In the Drawings:

Remarks

Objections to the Drawings

Fig. - 1

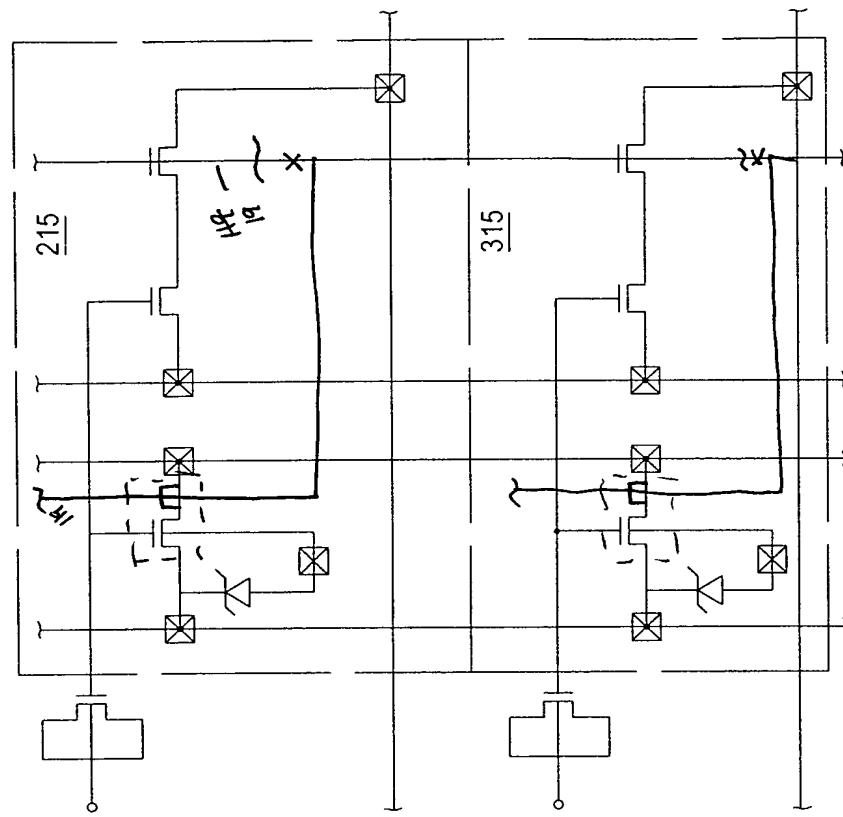
The Examiner suggested several minor changes to the drawings to correct discrepancies. Each suggestion is discussed in turn.

Element 28 of Fig. 1: The designation of the anode of diode 29 as element "28" has been removed. Element "28" remains a contact of transistor 23.

Fig. 1 has been amended to remove duplicate label "28" from the cathode of diode 29. Contact 28 remains. Word line 19 has been redrawn and word line 119 has been added for consistency with Figs. 2 & 4.

*Fig. 3**Fig. 4*

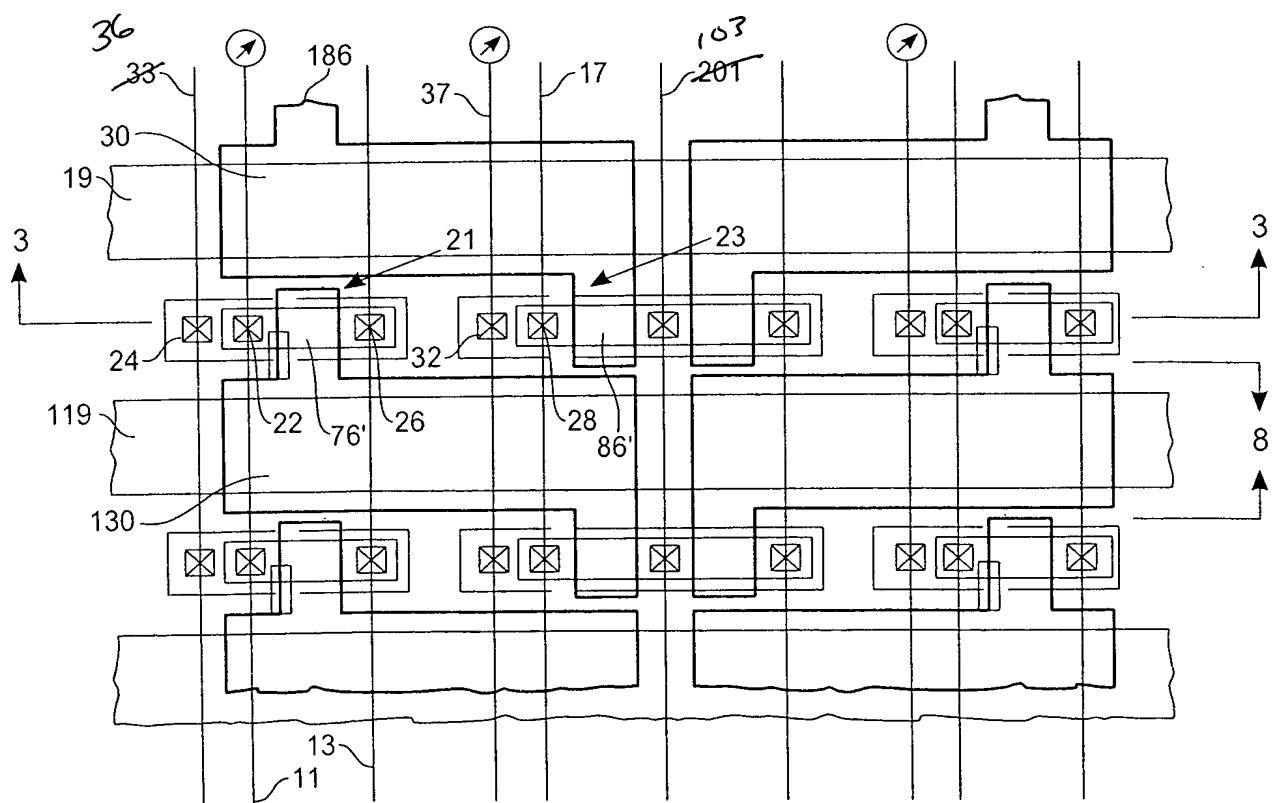
Line 201 of Fig. 4: Element 201 has been re-designated "actuation line 103". Element number 101 is present in Fig. 3. Element 201 is present in Fig. 8. The reference in the specification to "shared line 101" has been deleted.

Fig. 4 has been amended to re-designate unidentified line "201" to "103." Line '33" has been relabeled "36" for consistency with Figs. 1 & 2.

Fig. 8

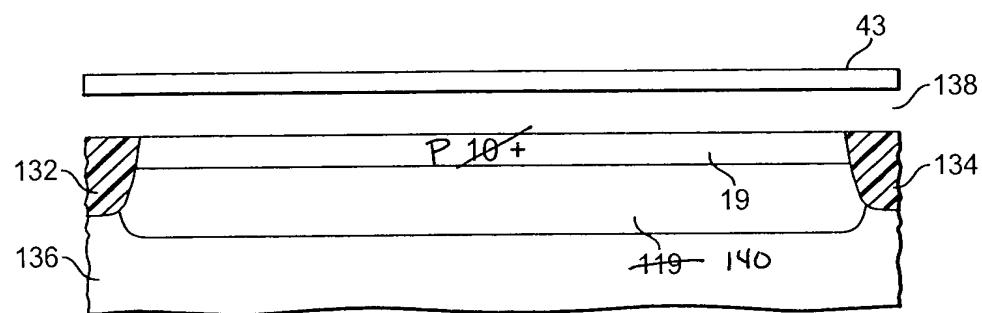
Nwell 119 of Fig. 8: Fig. 8 has been revised. Element 119 has been re-designated "103;" the label "10+" has been changed to "P+" to correct a scrivener's error.

Fig. 8 has been amended to re-designate element (Nwell) "119" as element "140." Word line 119 is present in Figs. 2 & 3.
